NOTICE TO CONTRACTOR

APPROVED

McKee Homes, LLC
Lot 1019 Anderson Creek Carriage Glen
Torino II Craftsman
RH Monoslab Foundation

FIRST FLOOR FRAMING PLAN

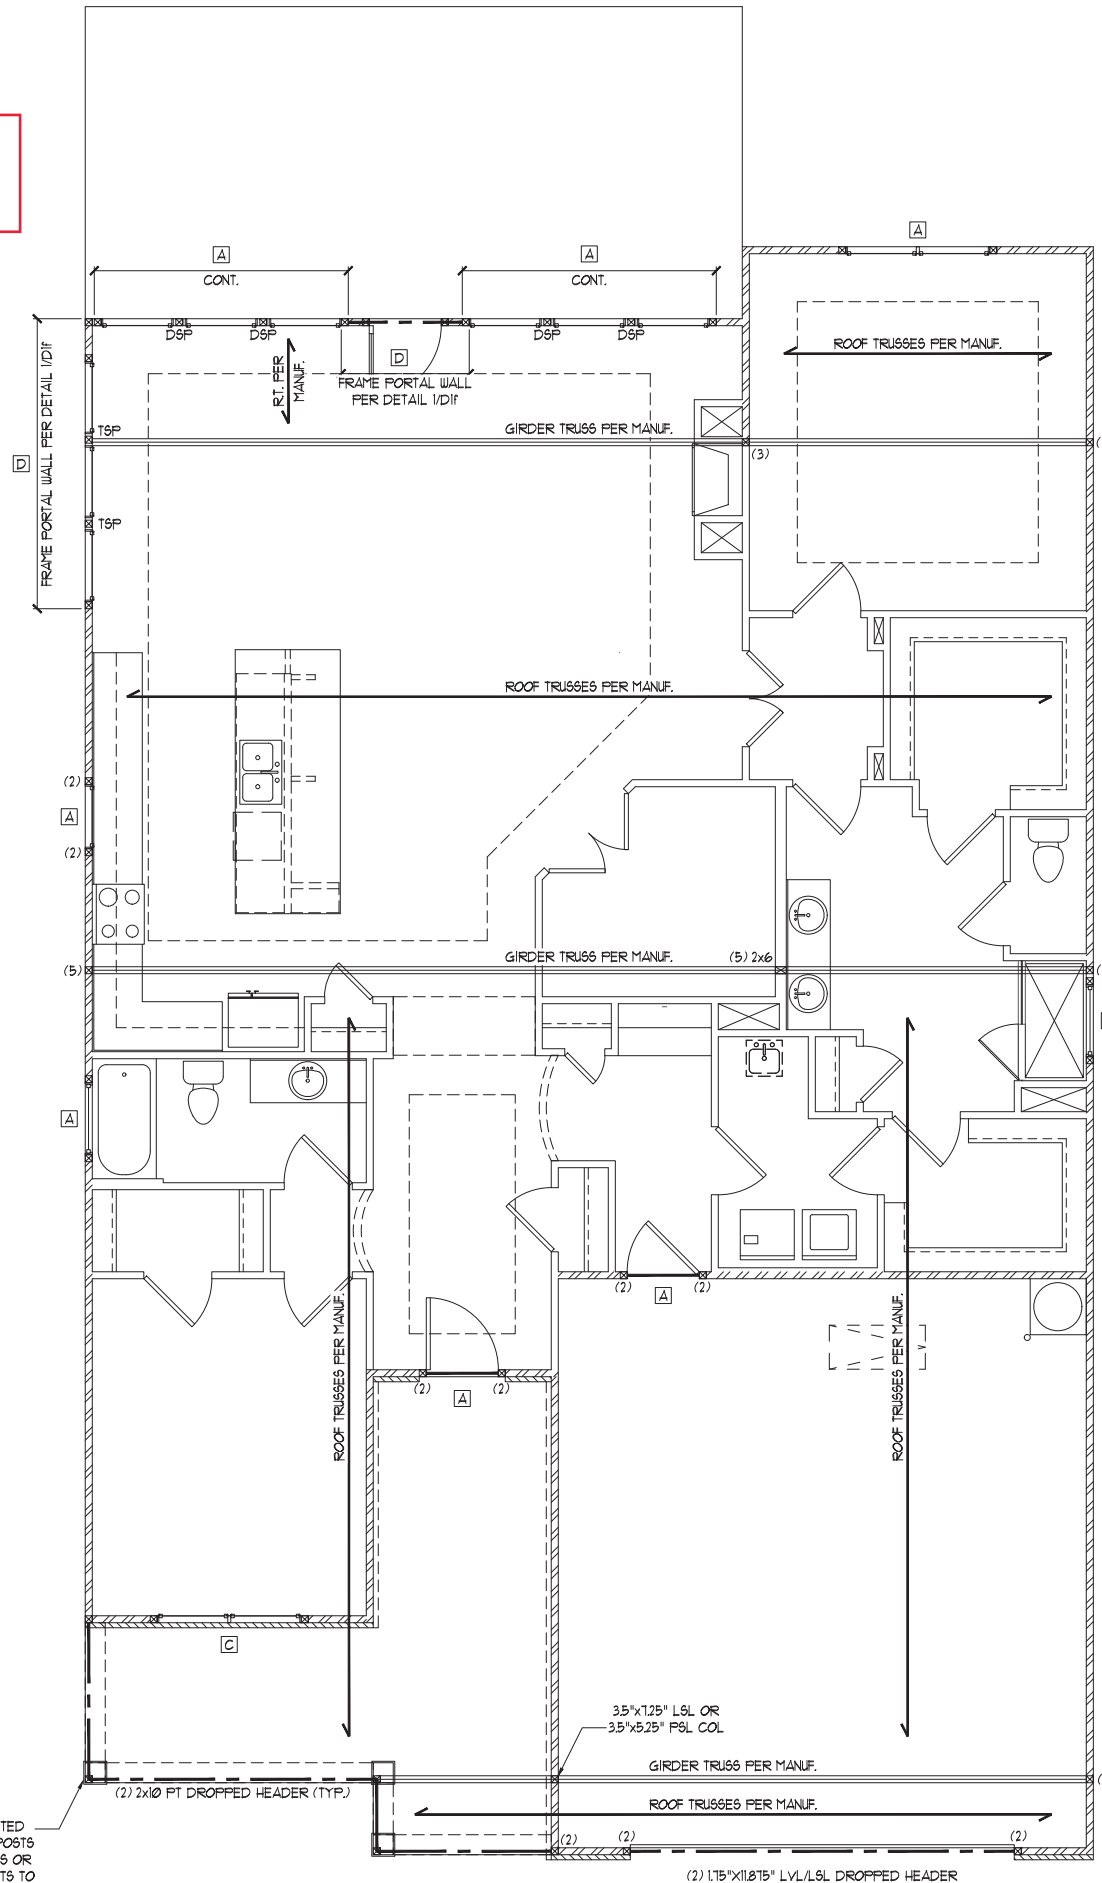
Covered
Porch - see
next pg

Sitting Room
- See next pg

L Shaped
Shower -
See detail
below

ROOF FRAMING PLAN
 SCALE: 1/4"=1'-0" ON 22'x34" OR 1/8"=1'-0" ON 11'x11"

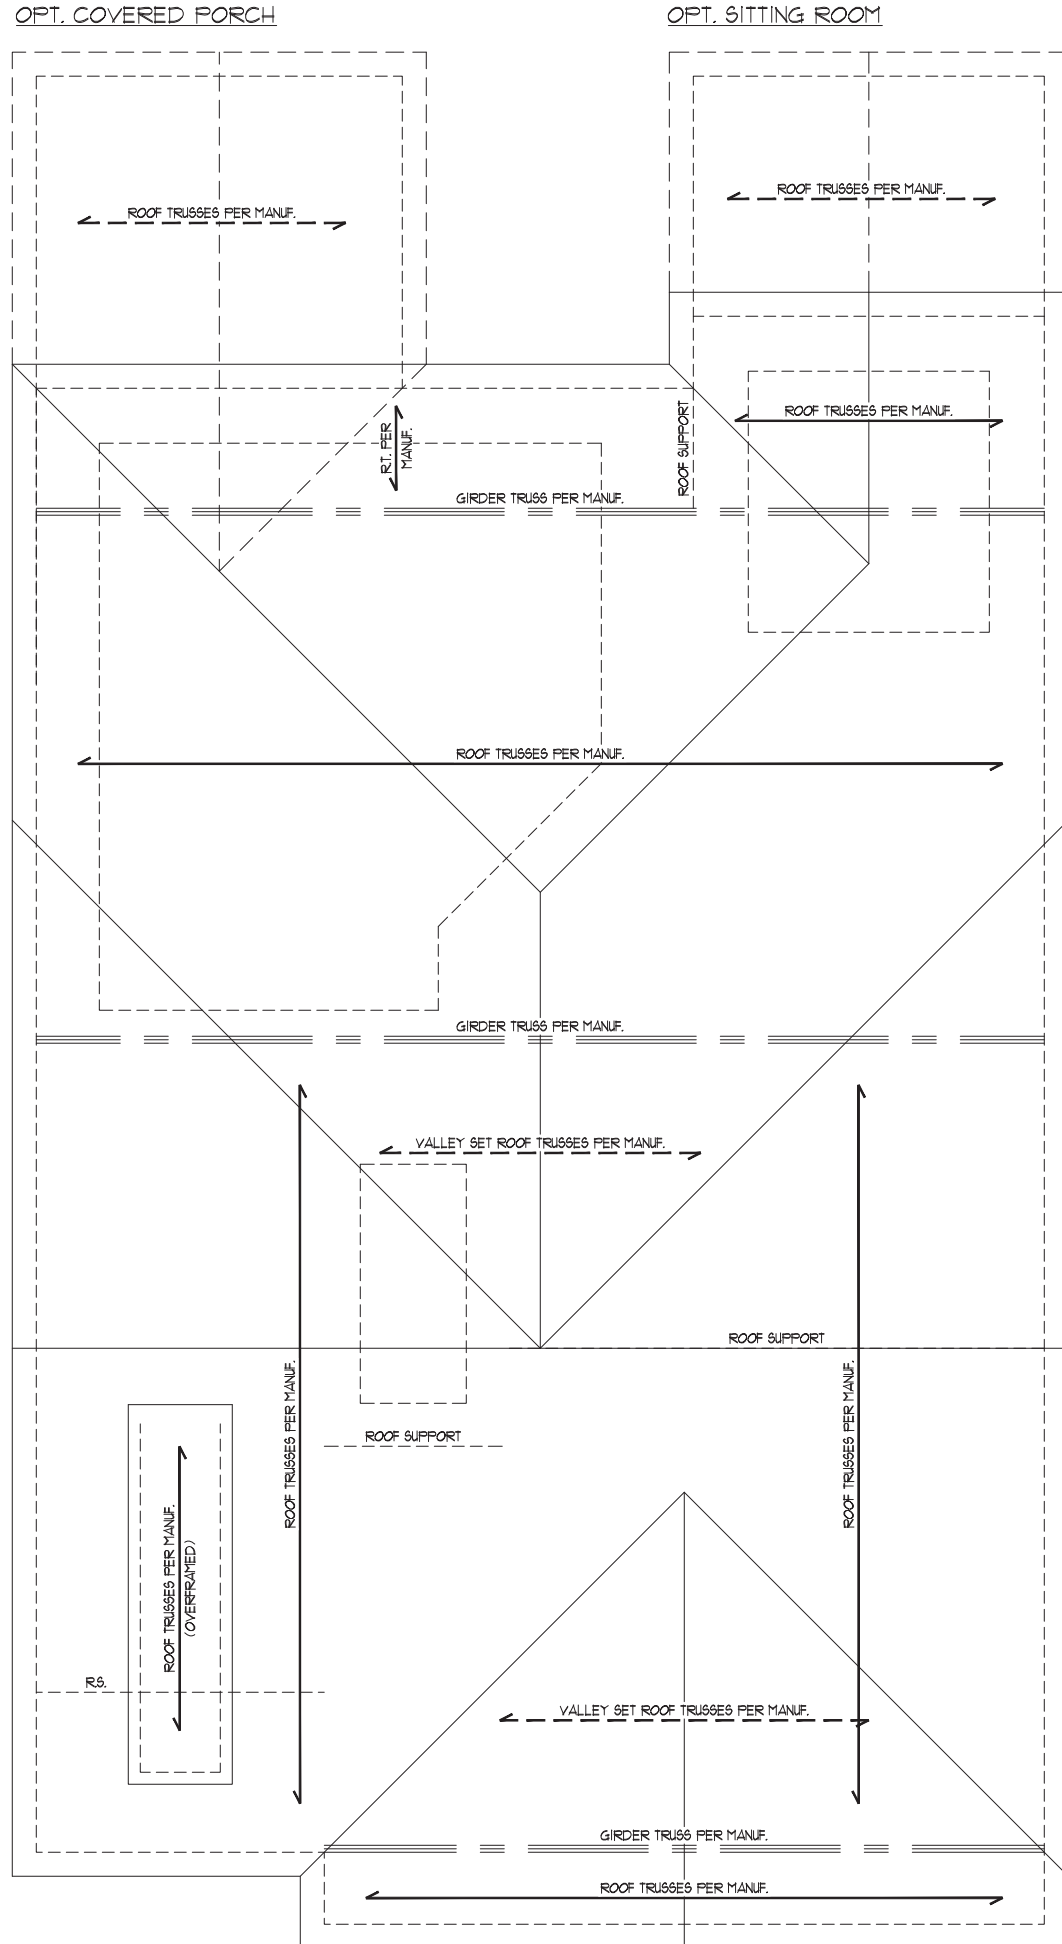
Add Covered Porch

Add Sitting Room
